AMENDMENTS TO THE DRAWINGS:

REMARKS

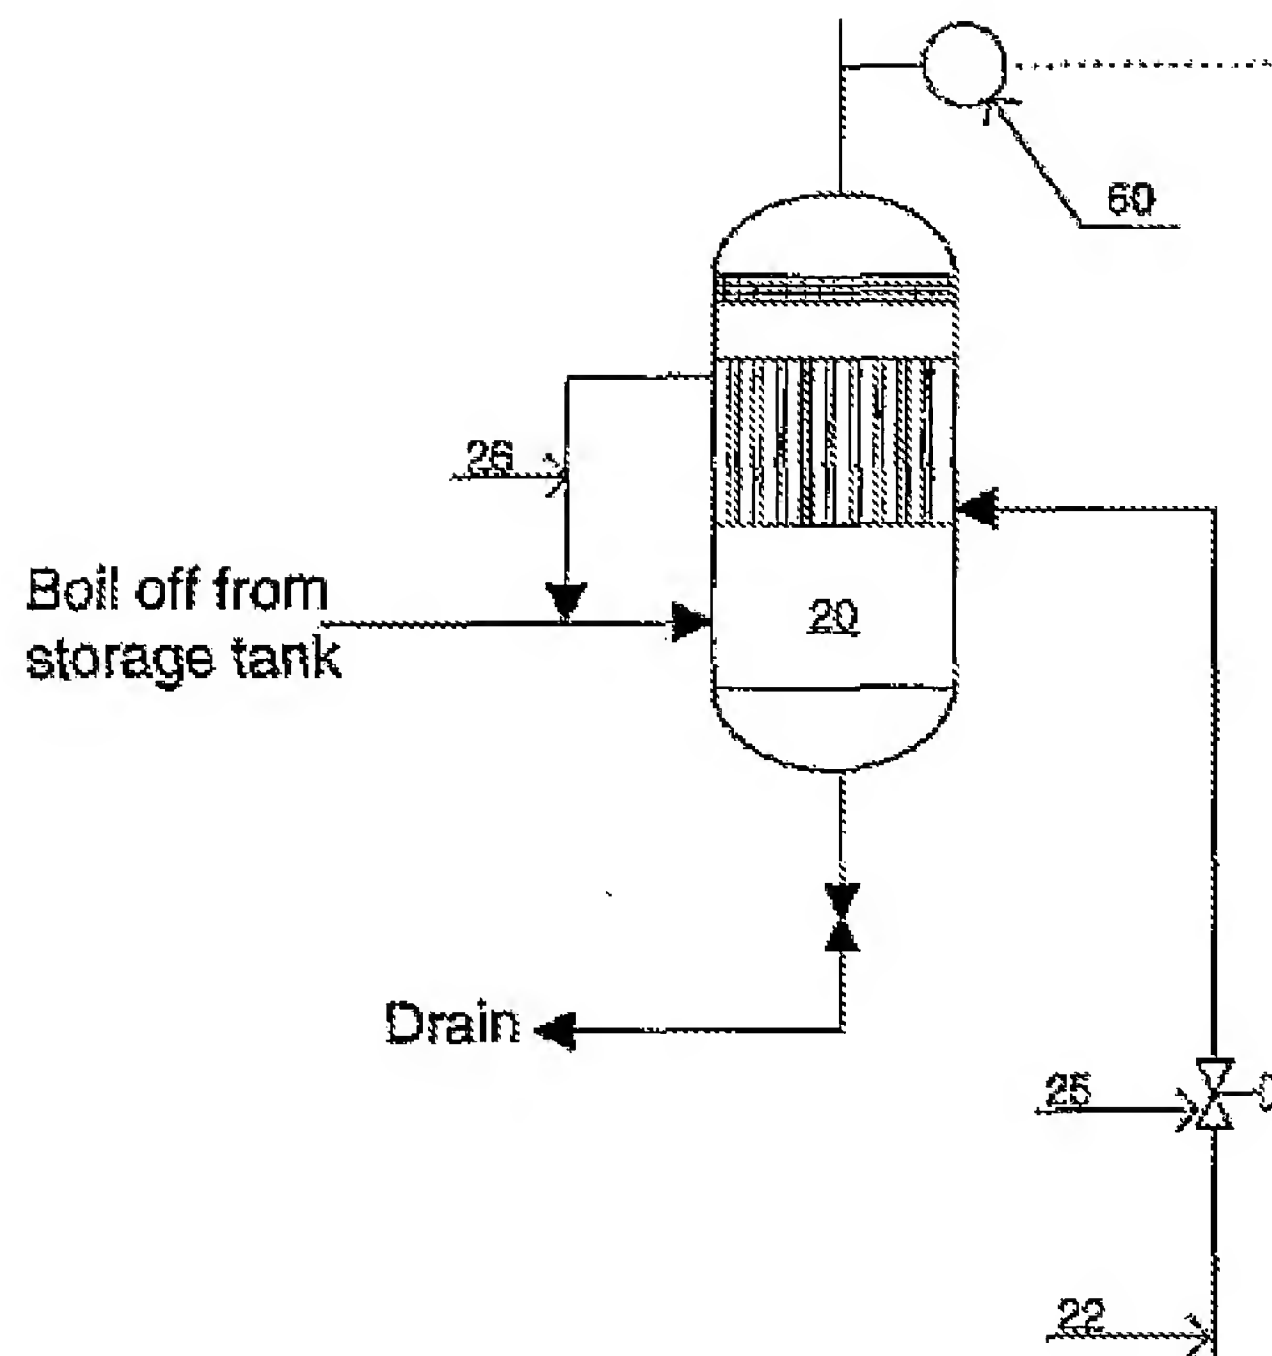
The Official Action objected to the drawing figures, stating that Figure 1 should include a legend such as "Prior Art" because only that which is old is illustrated.

As to claim 2, the Official Action alleges that it is unclear how mixing of evaporated LNG with boil-off gas occurs upstream of the heat exchange.

As to claim 8, the Official Action alleges that it is unclear how the combined mist separator and head exchanger can be connected to the feed line upstream from itself.

In response, Figure 1 is amended to include a legend "Prior Art". Withdrawal of the objection to the drawings is thereby respectfully solicited.

In reply, claims 2 and 8 are amended as indicated above to clarify the recited features. It is further respectfully submitted that a mixing of fully evaporated LNG with boil-off gas upstream of the heat exchange, as recited by claims 2 and 8, is adequately disclosed by the specification and the drawing figures as originally filed such that one of skill can readily comprehend the make the invention.

For example, Figure 2 (detailed above for the Examiner's convenience) discloses a "second conduit 26 fluidly connects the heat exchanger 20 to the boil-off gas feed line at a point upstream of the heat exchanger 20," (page 5, lines 14-15), wherein the heat exchanger is connected at its other side to the line carrying LNG from the cold box 30 to the storage tank (page 5, line 1 and lines 11-14). The arrowed line extending from the legend "Boil off from storage tank" clearly indicates the boil-off gas feed line with a direction toward the combined mist separator and heat exchanger 20. The second conduit 26 meets the boil-off gas feed line at a point prior to the intersection with the combined mist separator and heat exchanger 20.

Hence, LNG fully evaporated by the combined mist separator and heat exchanger 20 mixes with the boil-off gas at a

location upstream of said boil-off gas entering the combined mist separator and heat exchanger 20.
